PROPOSED HIGH-RISE MIXED-USE DEVELOPMENT **1950 Scott Street and 312 & 314 Clifton Road**

Development Servicing Study and Stormwater Management Report

**Markup for ZBLA Submission September 16th, 2024
(See Accompanying Memorandum for Details)**

Ref: R-2024-087
Novatech File No. 121301

LOCATION		PROJECT No.	
CITY OF OTTAWA 1950 SCOTT STREET AND 312 & 314 CLIFTON ROAD		121301	
DRAWING NAME		REV #	
GRADING AND EROSION AND SEDIMENT CONTROL PLAN		REV #1	
Markup for ZBLA Submission September 16th, 2024		DRAWING No.	
		121301-GR

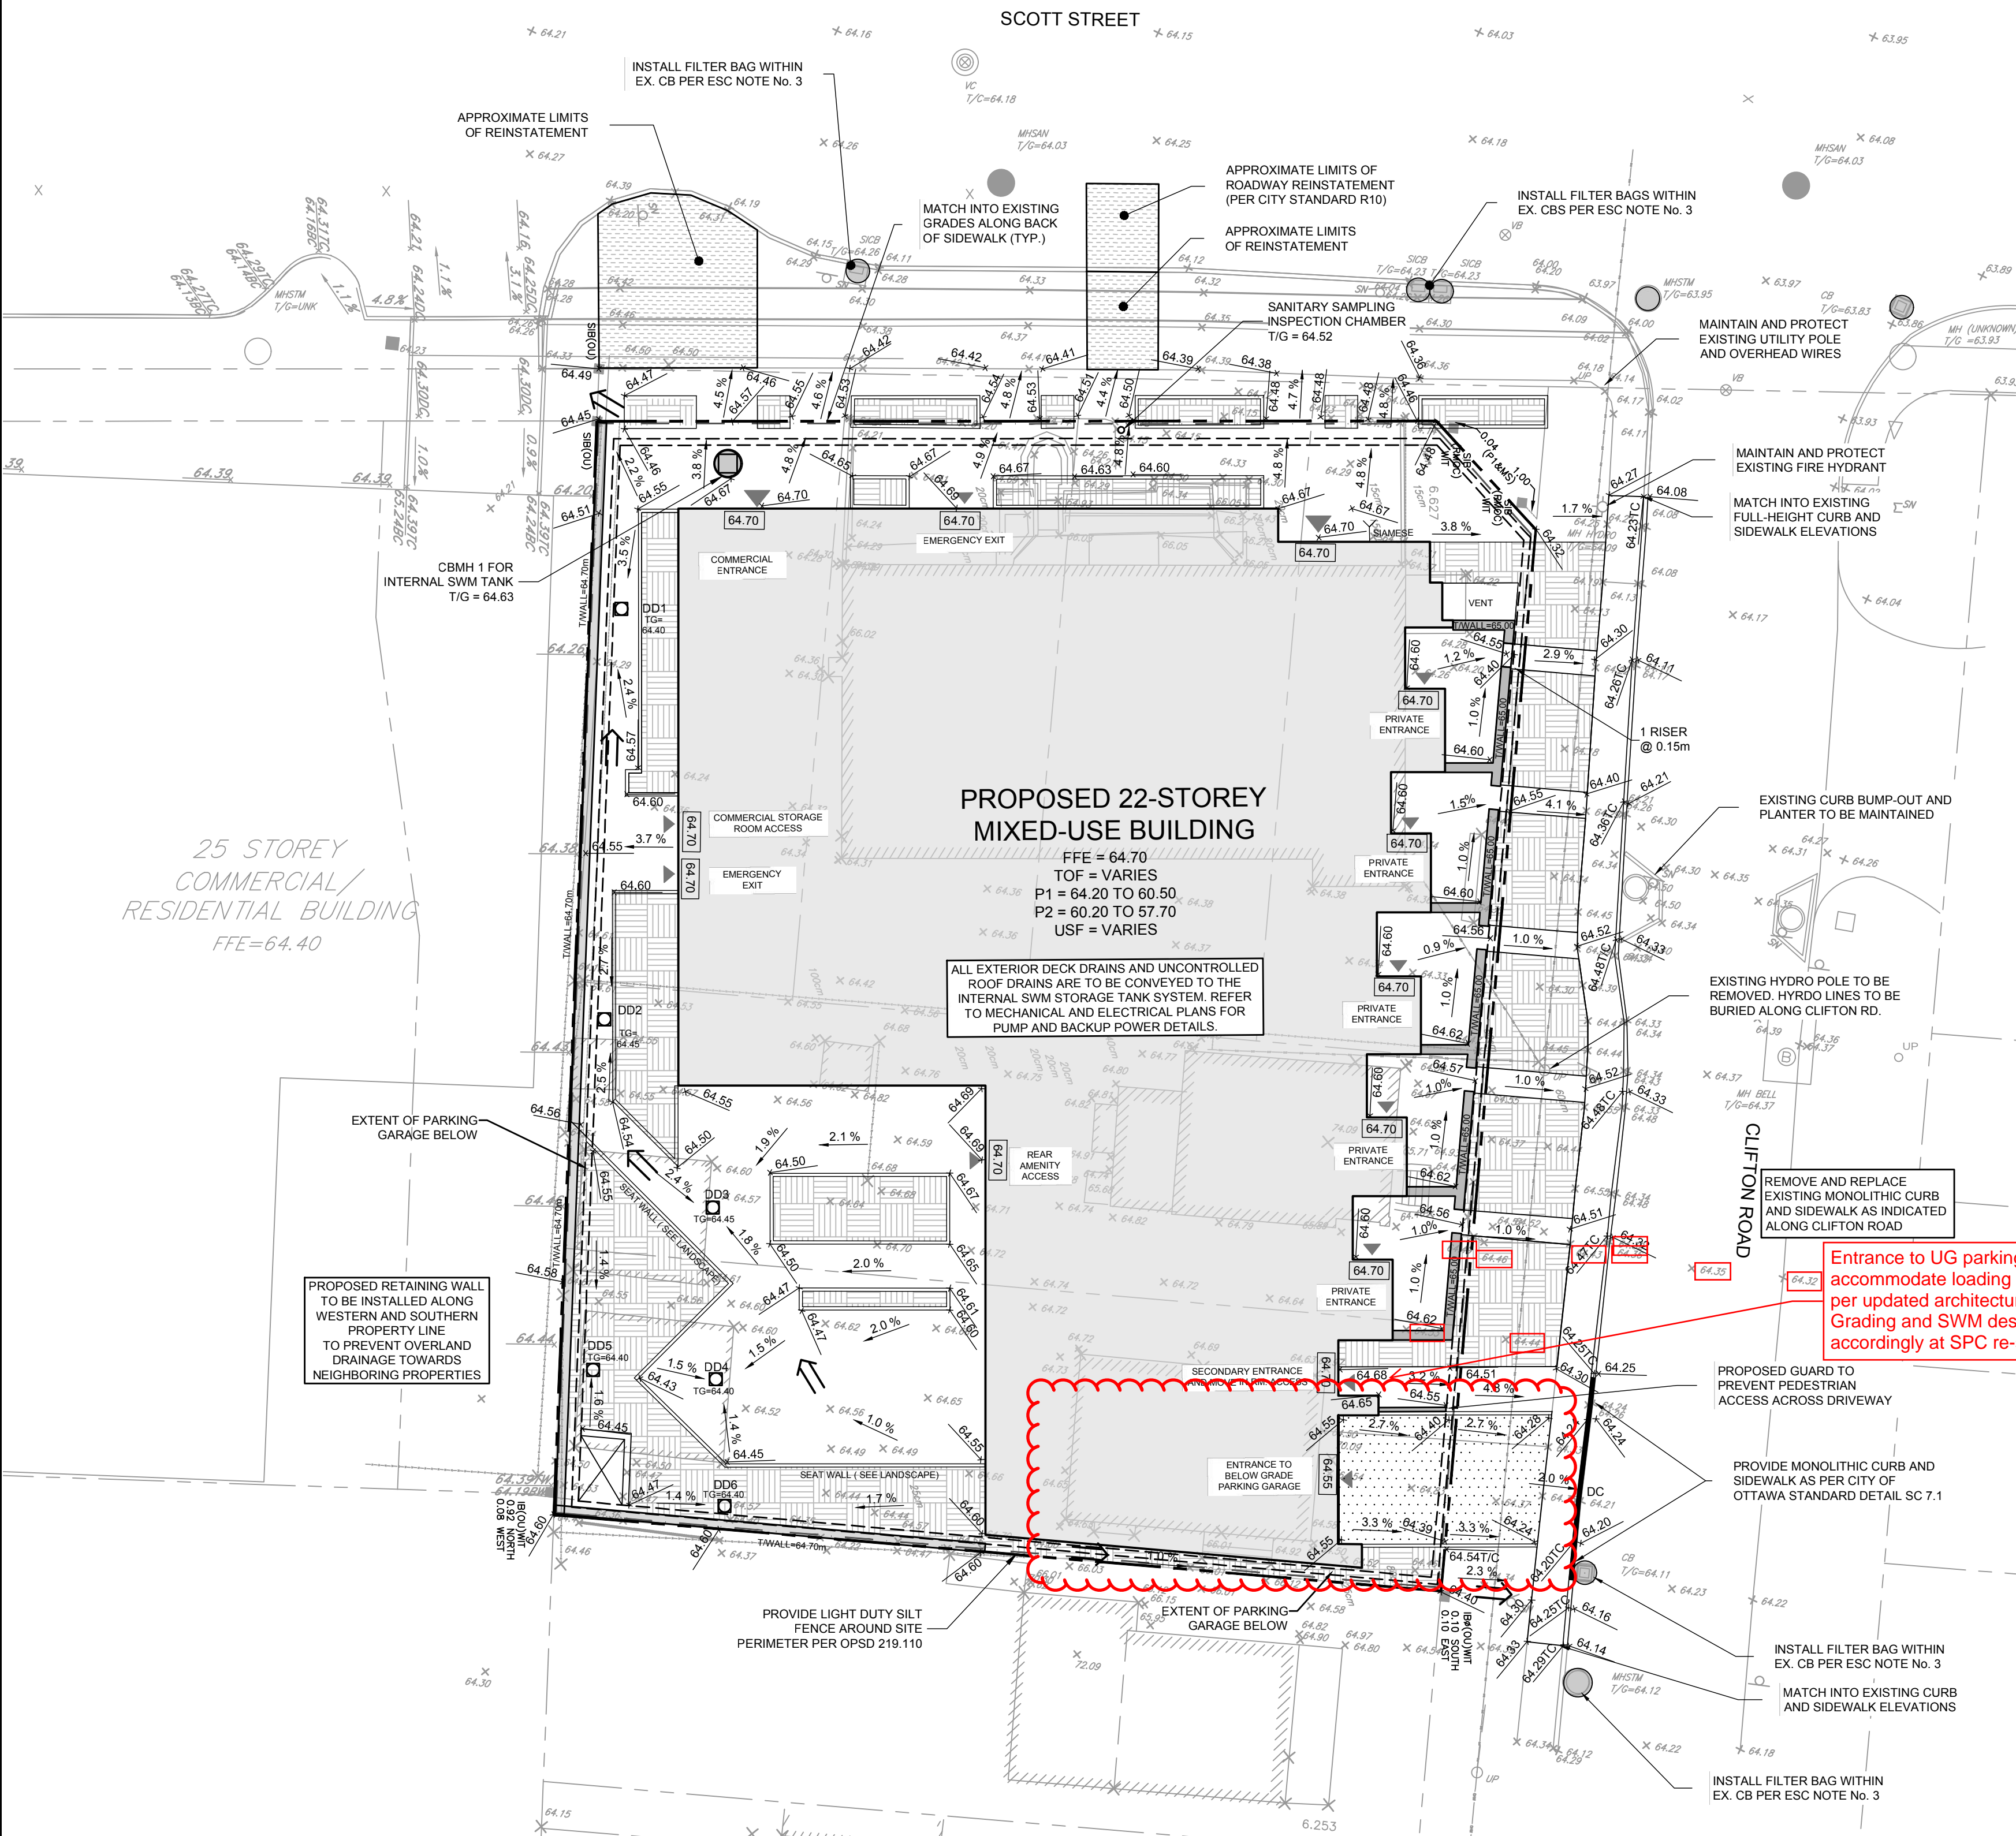
Entrance to UG parking to be shifted north to accommodate loading area along property line as per updated architectural Site Plan. Grading and SWM designs to be revised accordingly at SPC re-submission stage.

POST-DEVELOPMENT CONDITIONS

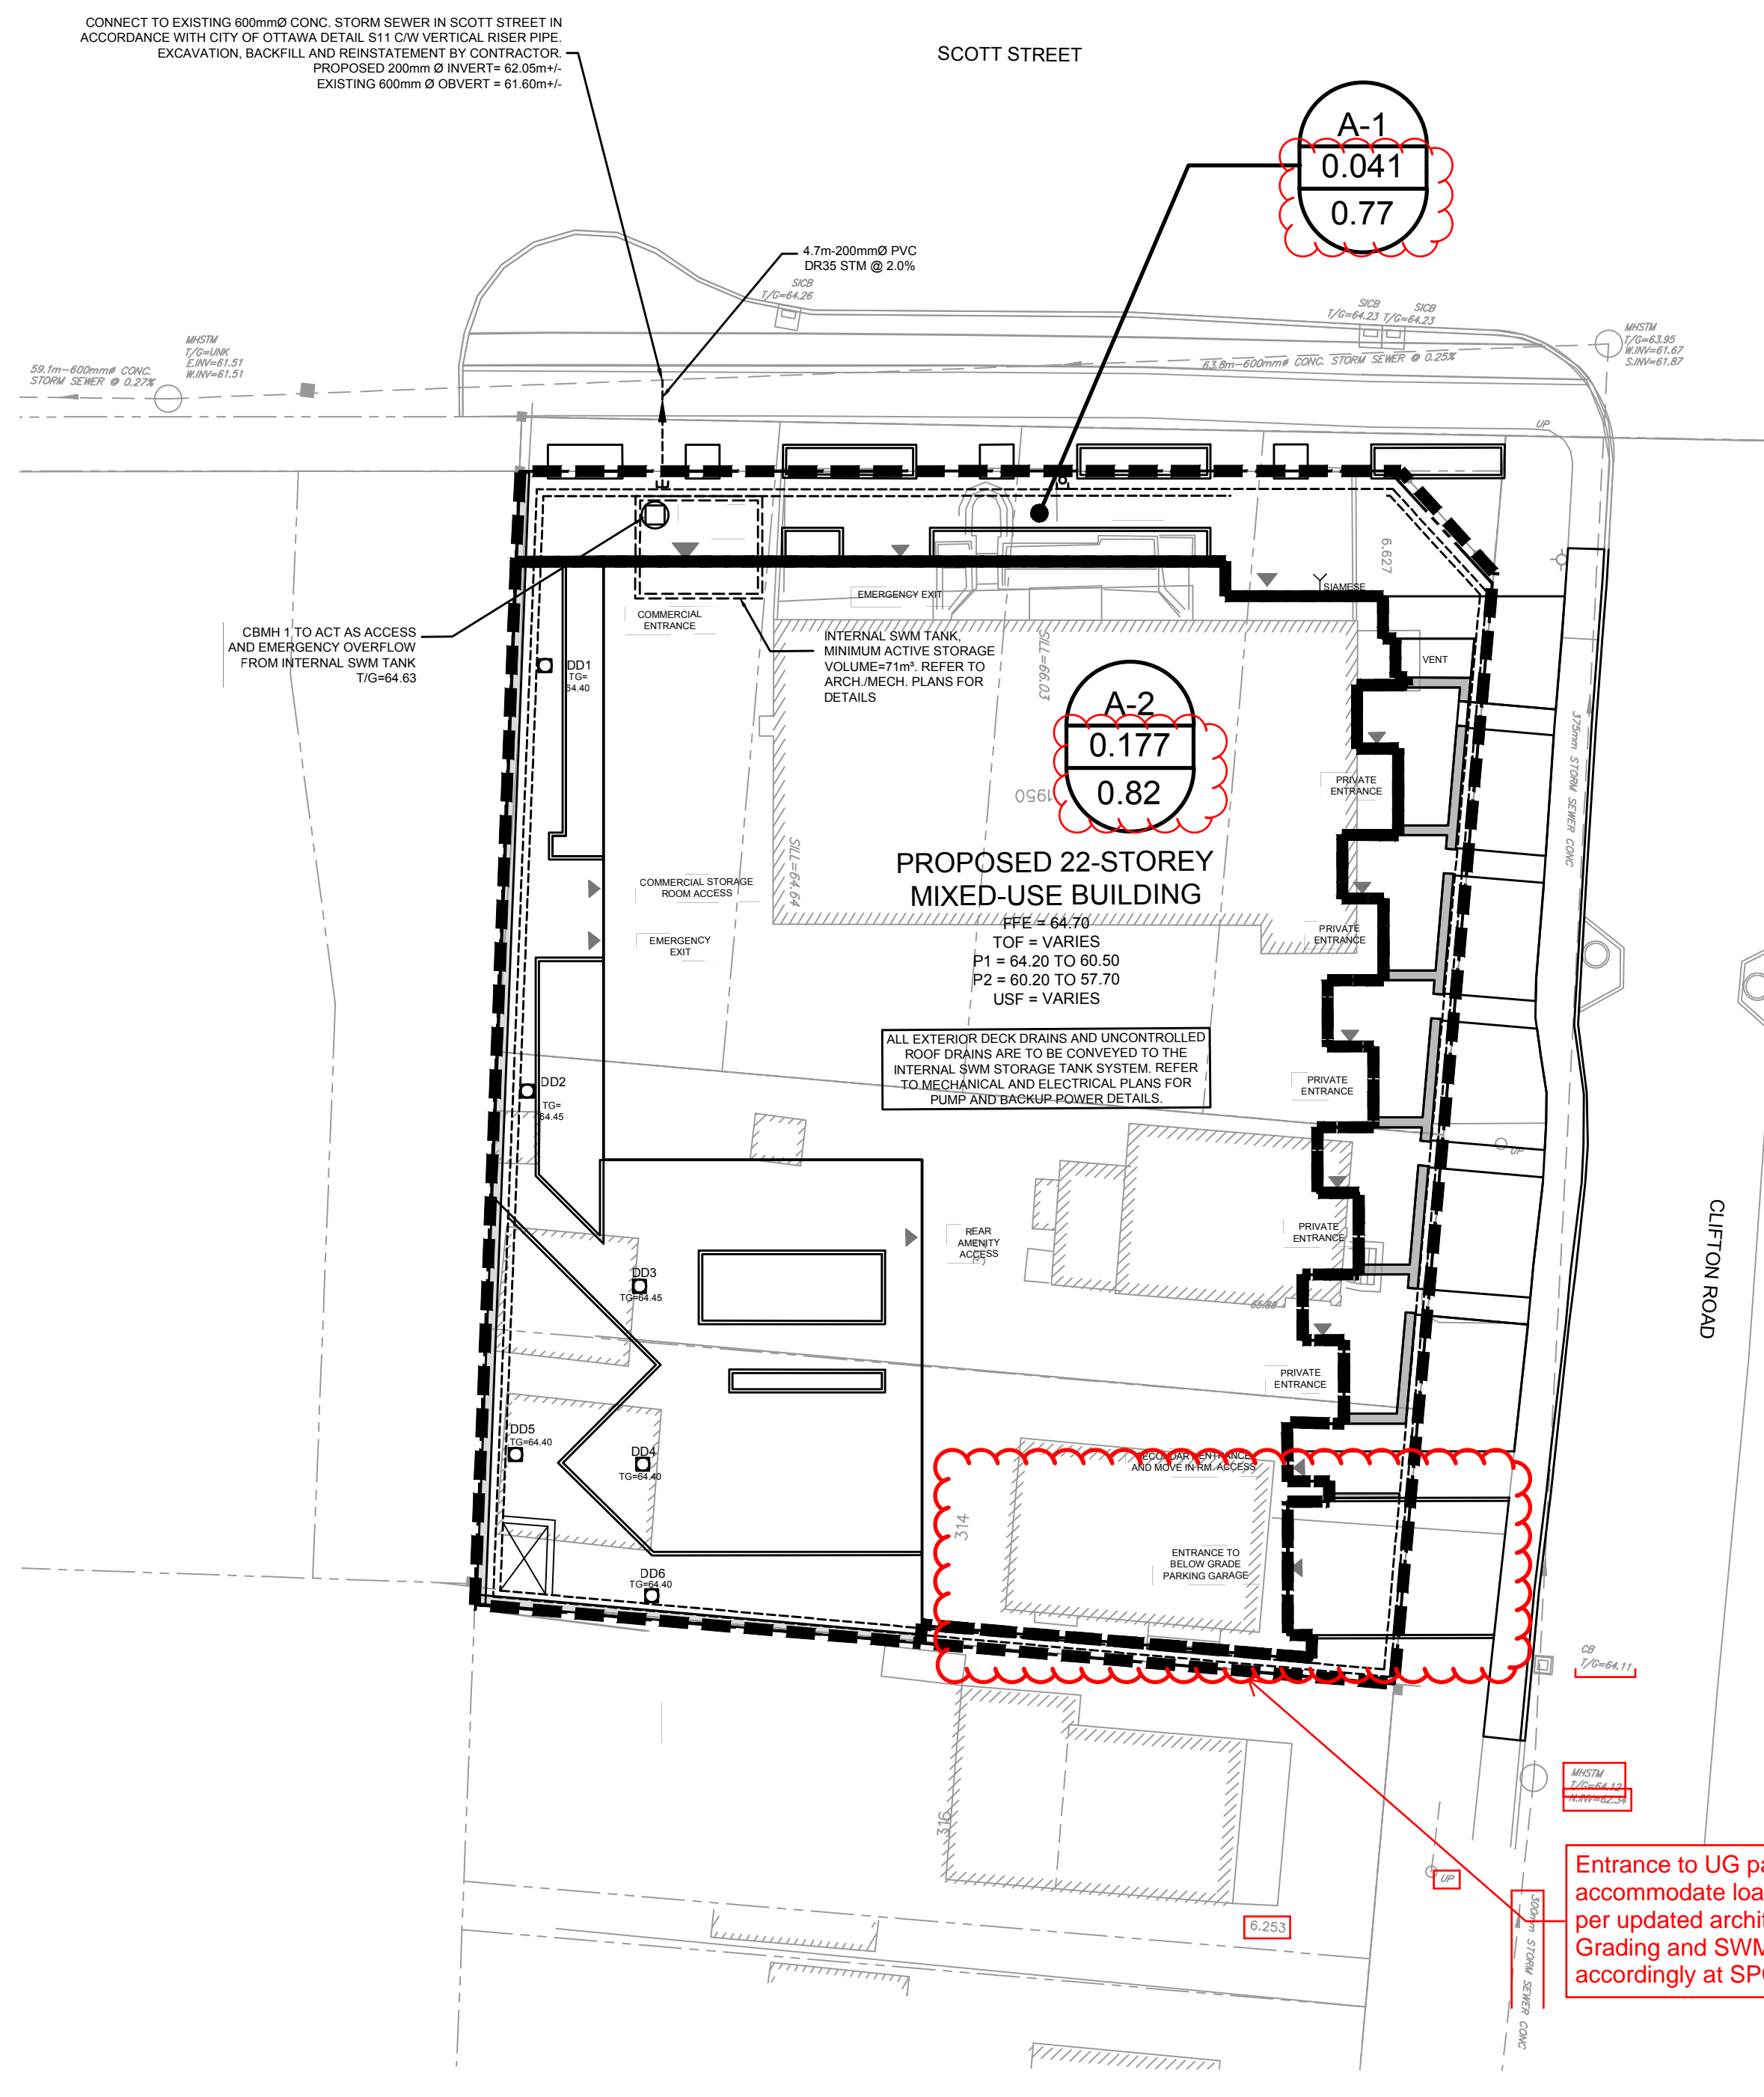
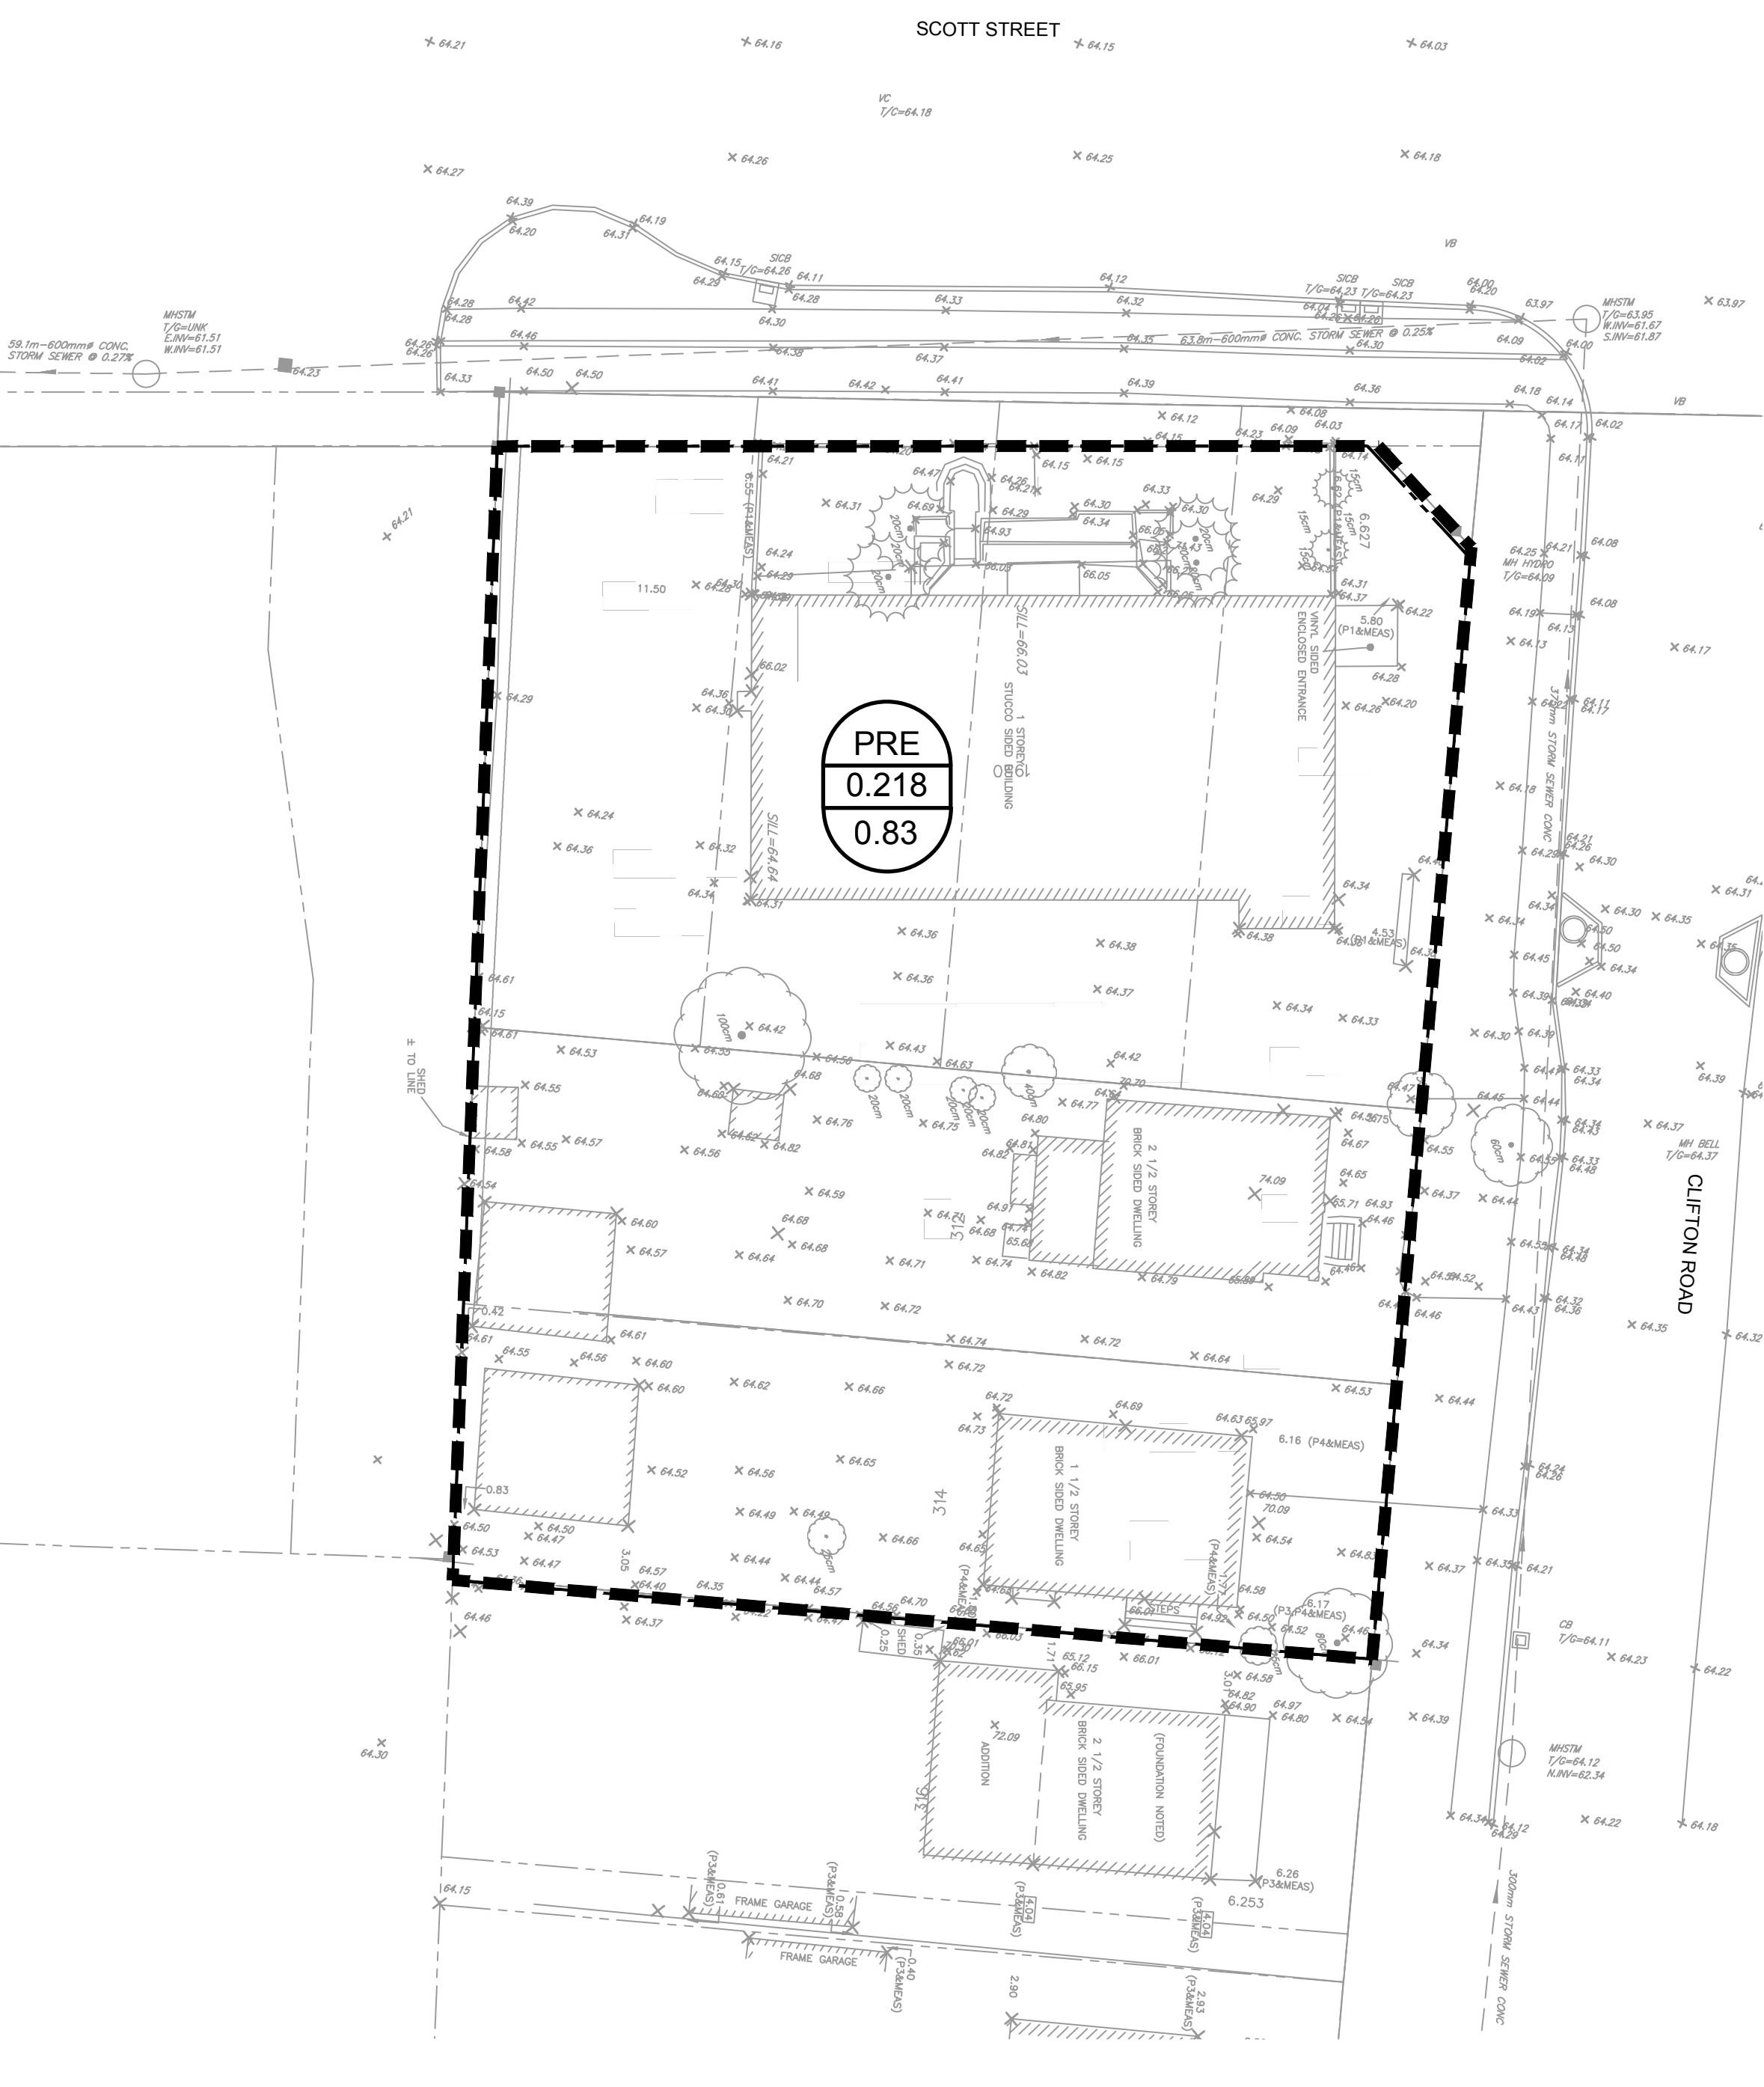
Post-Development drainage areas and 1.5 year weighted runoff coefficients may be updated based on shifted UG Parking access and loading area.
